## DRAFT AMENDMENT C244 MELTON EAST PRECINCT STRUCTURE PLAN SUBMISSION

Veris acts on behalf of Maximise Group (Maximise), the owners of the land at 2231-2257 Melton Highway (the site) within the Melton East Precinct Structure Plan (PSP). The below sets out Maximise Group's formal submission to the release of draft Planning Scheme Amendment C244 that is intended to implement the Melton East PSP. The submission responds to key identified issues and constraints.

**SUBJECT: DRAFT AMENDMENT C244 MELTON EAST PRECINCT STRUCTURE PLAN  
SUBMISSION | SEWER AND DRAINAGE STRATEGY**

**2231-2257 Melton Highway, Melton**  
Melton East PSP - Altered Tarletons Road Alignment  
Concept Layout Plan - Overall View

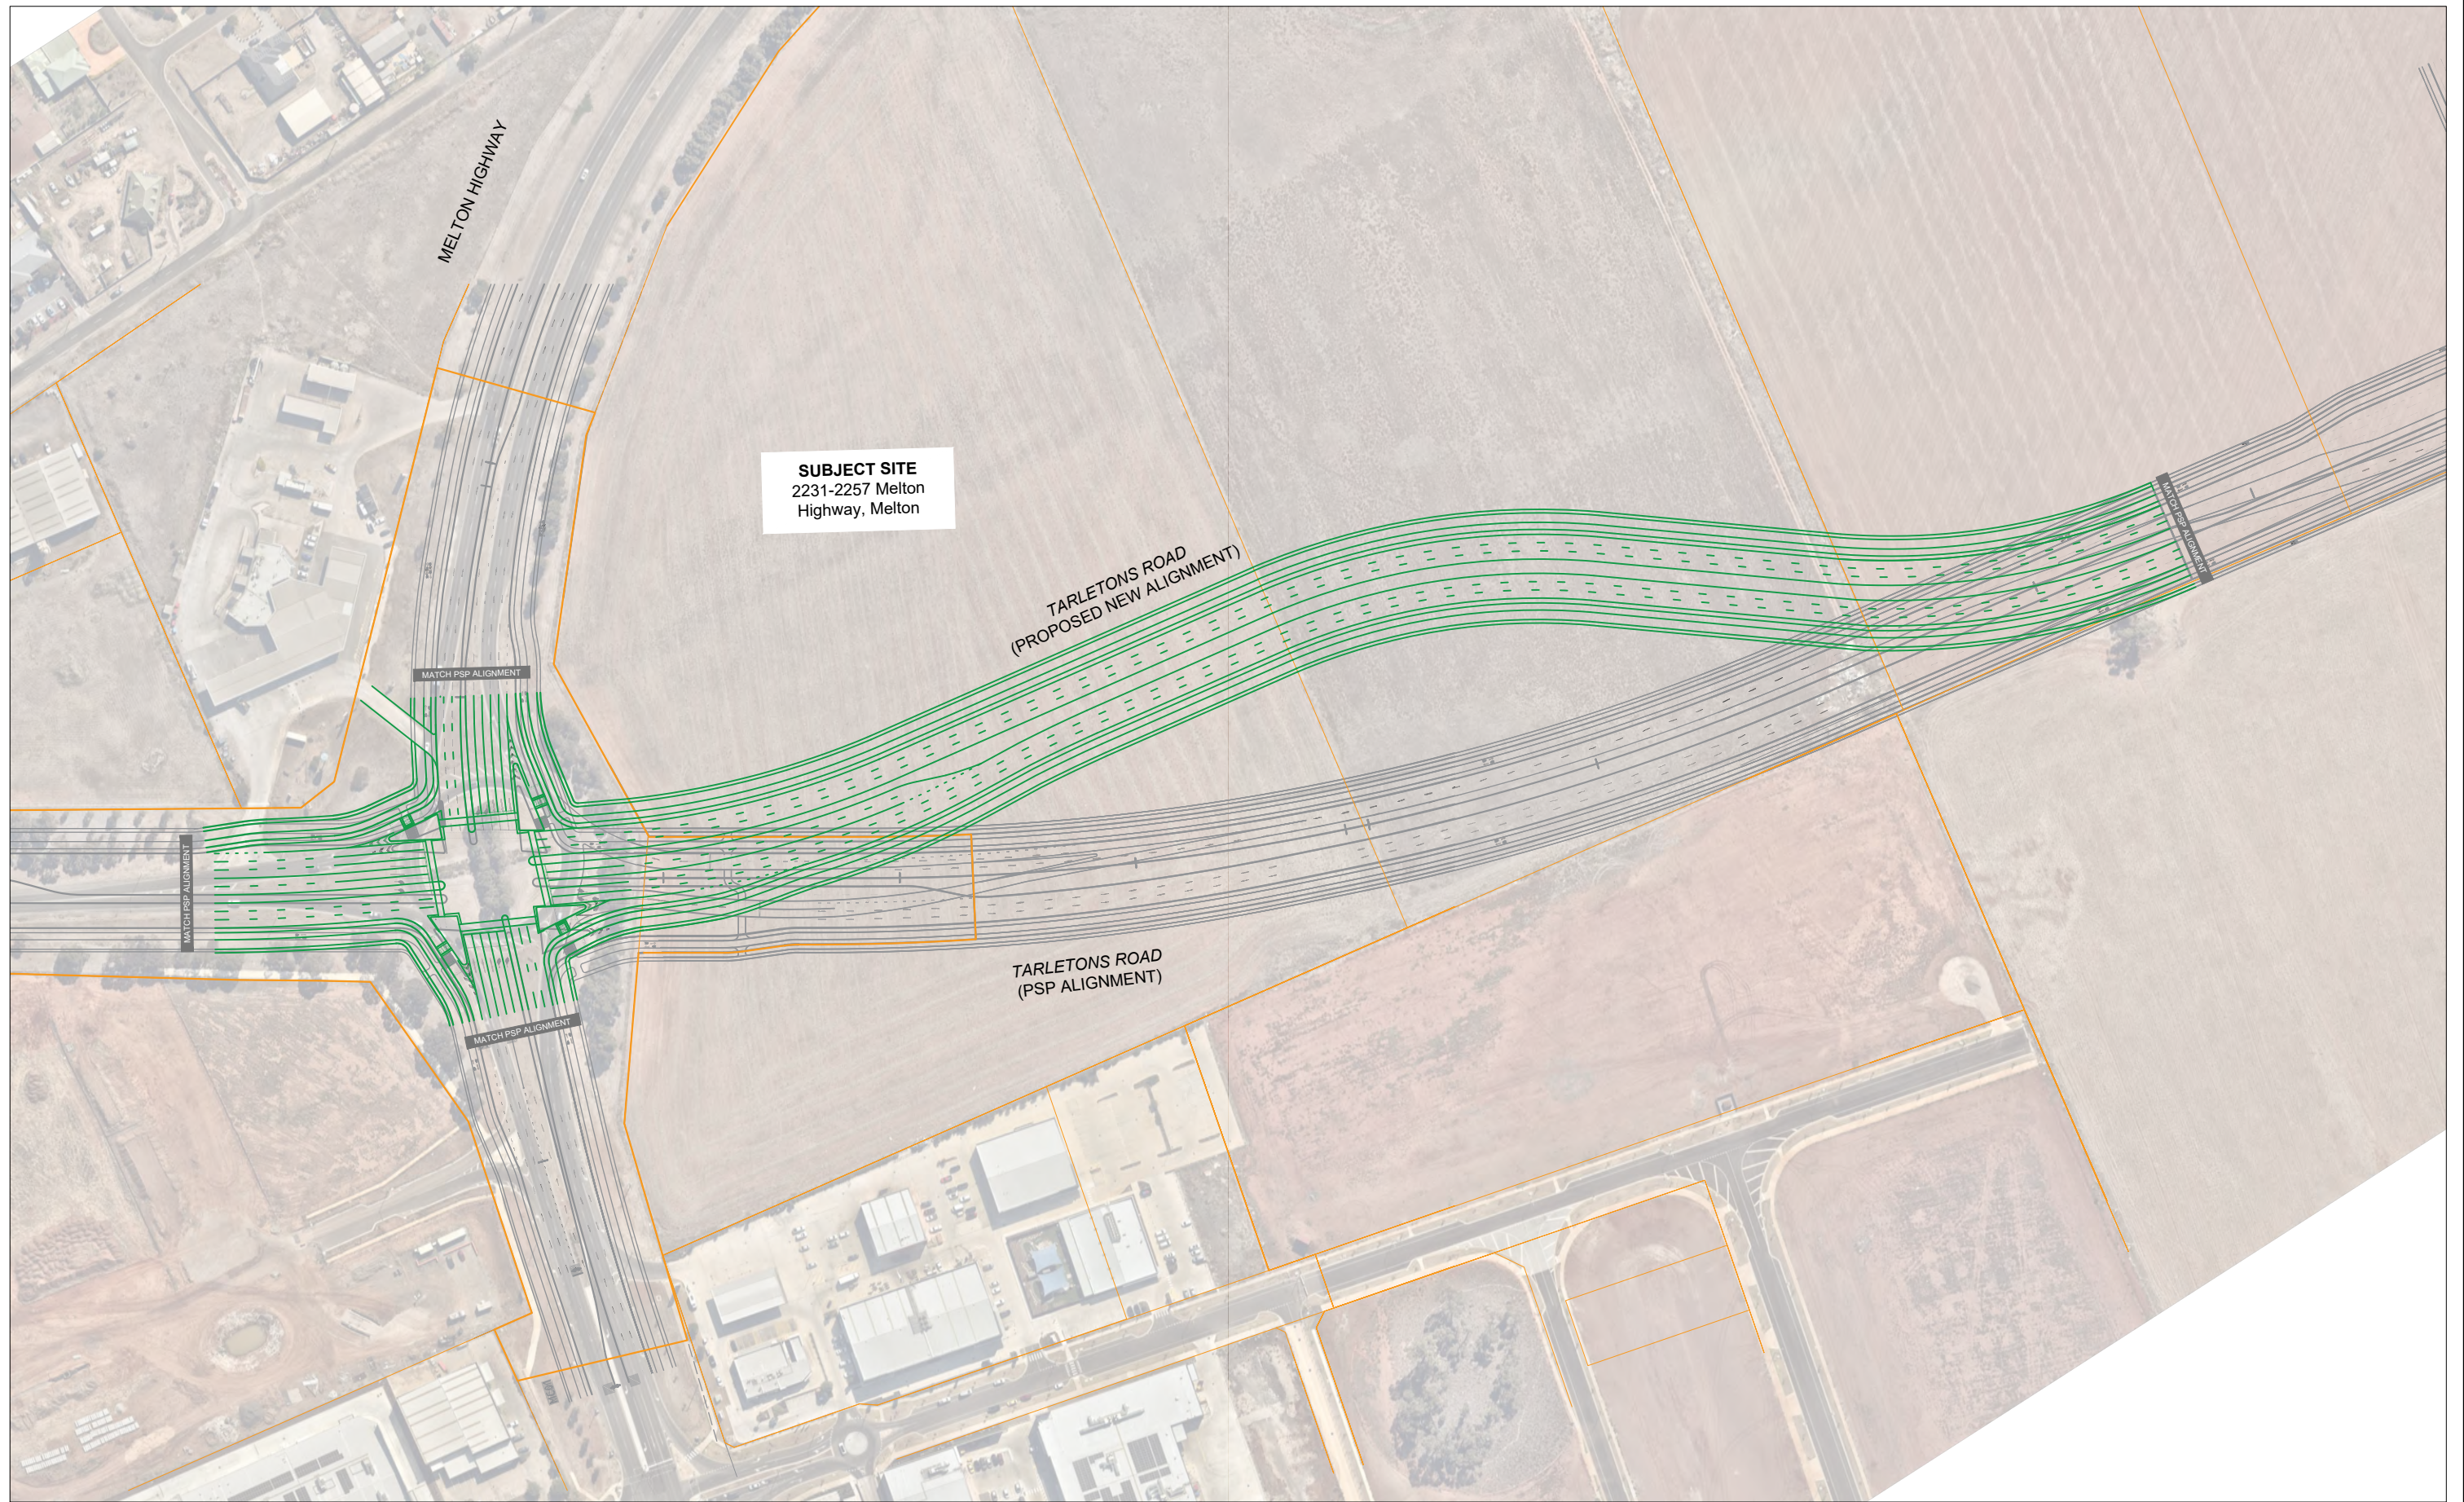
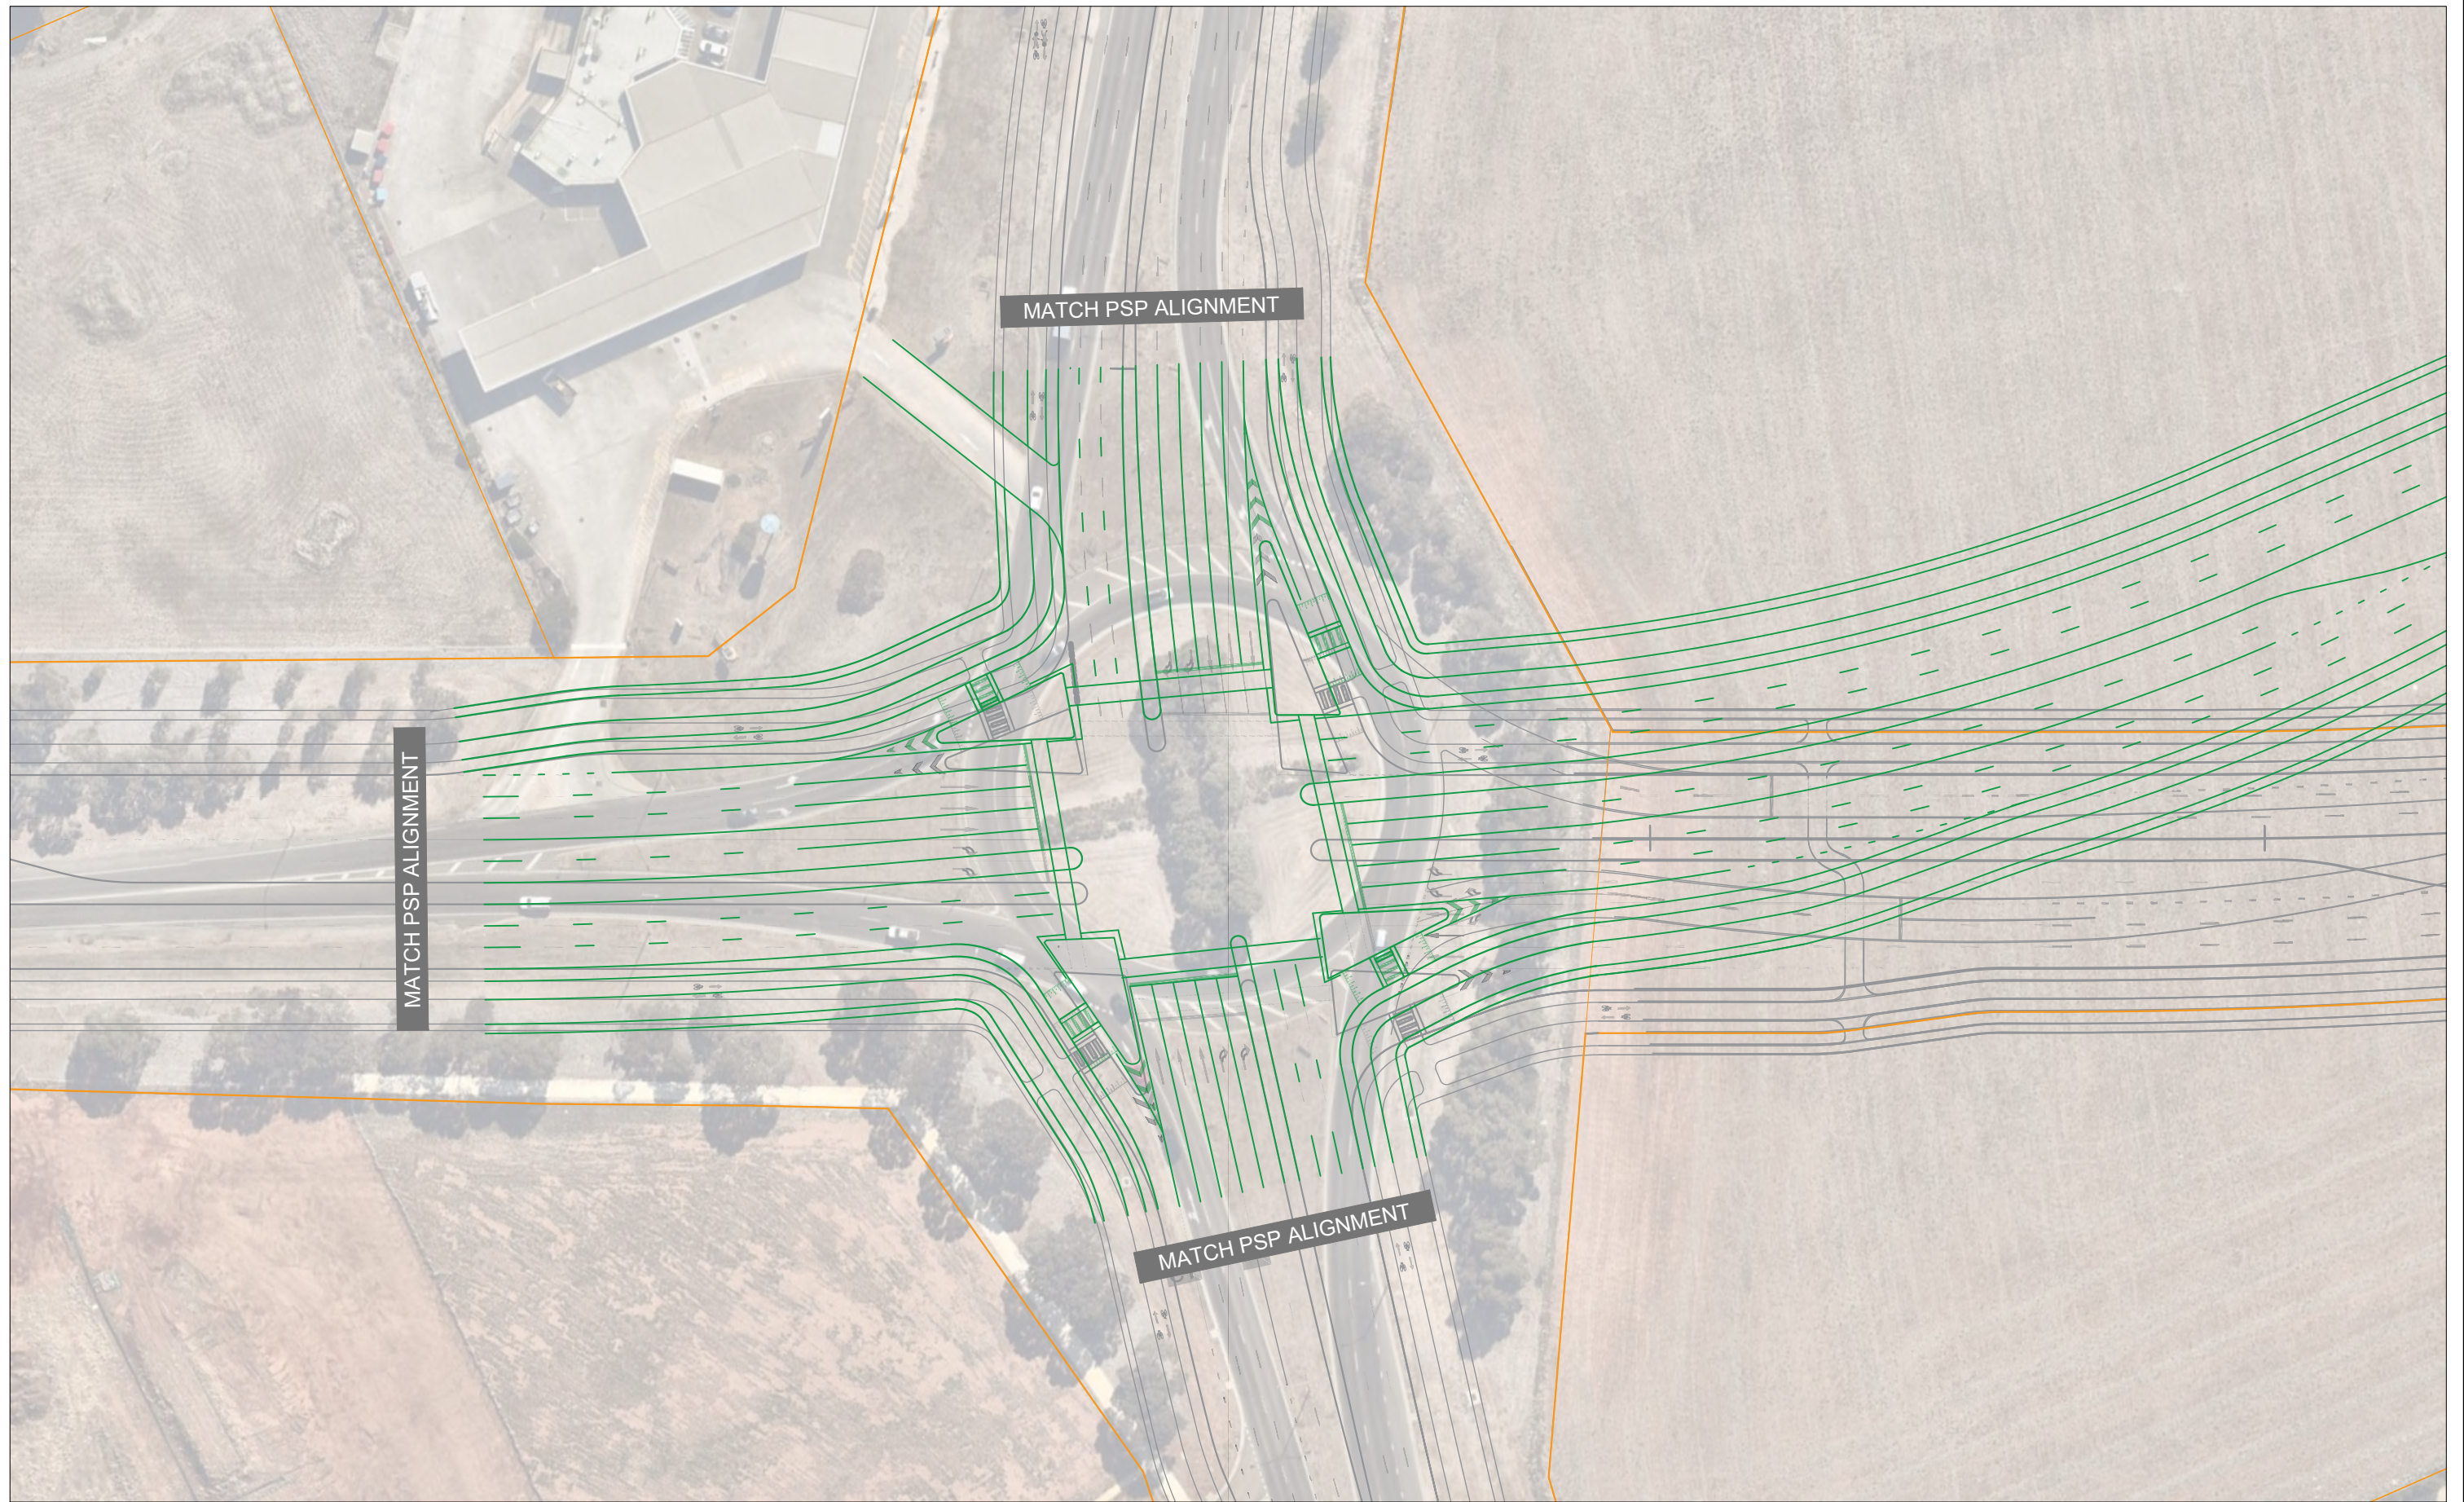
- Current alignment of Tarletons Road severs the site and creates irregular land parcels that cannot be easily accessed by vehicles to the south. The current alignment has been reviewed by a traffic engineer and we propose an alternative alignment in compliance with relevant Austroads design guidelines. This realignment results in increased NDA for both our site and the site to the east which is considered a highly beneficial outcome for the overall precinct. Please refer to Appendix 1 Concept Plan package prepared by Studio Way for details of the proposed realignment.

- NOTES:
1. East-west curved alignment based on design criteria for in AustRoads GTRD Part 3 - Geometric Design.
